Title	Volvo Chassis - Model VNX - One Piece Propeller Shaft (Drive Shaft) Contacts Crossmember - Vehicles Built Between 4 November 2018 And 1 February 2020
Volvo Models	
Volvo Model	VNX
Engine family	
Engine family	16L Engine , CU15
Transmission	
Transmission	AMT-D , Eaton Fuller
** SOLUTION **

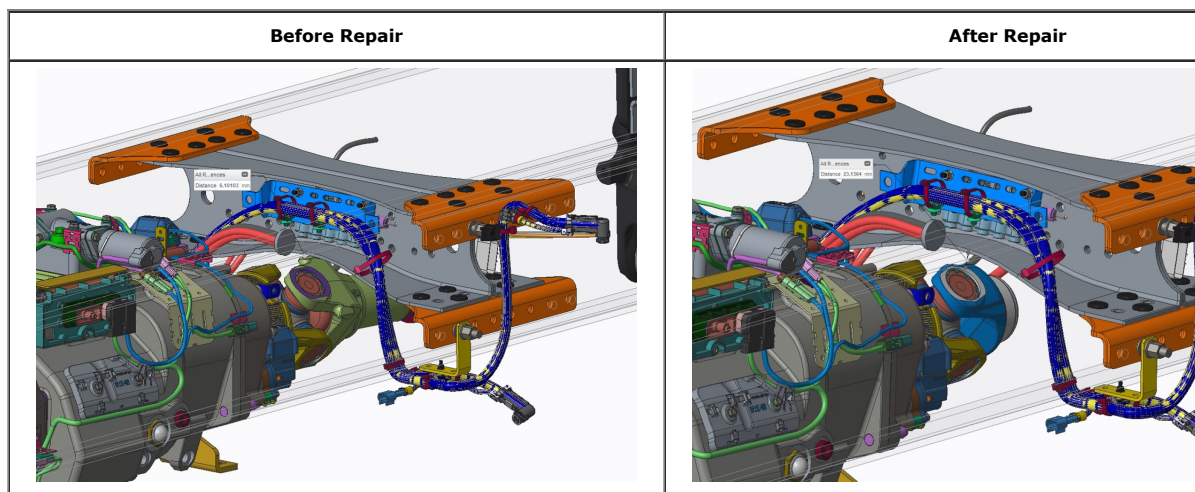
Cause	Due to close tolerances between the cross member and the propeller shaft on vehicles equipped with a one-piece shaft, the yoke of the drive shaft may contact the back to back "C" channel cross member under acceleration and/or suspension articulation.
Solution	For applicable vehicles with the symptom described above: 1. Remove the drive shaft. 2. Flip the shaft end-to-end (rear to the front, front to the rear). 3. Reinstall the flipped driveshaft.

Refer to the images below for proper appearance:
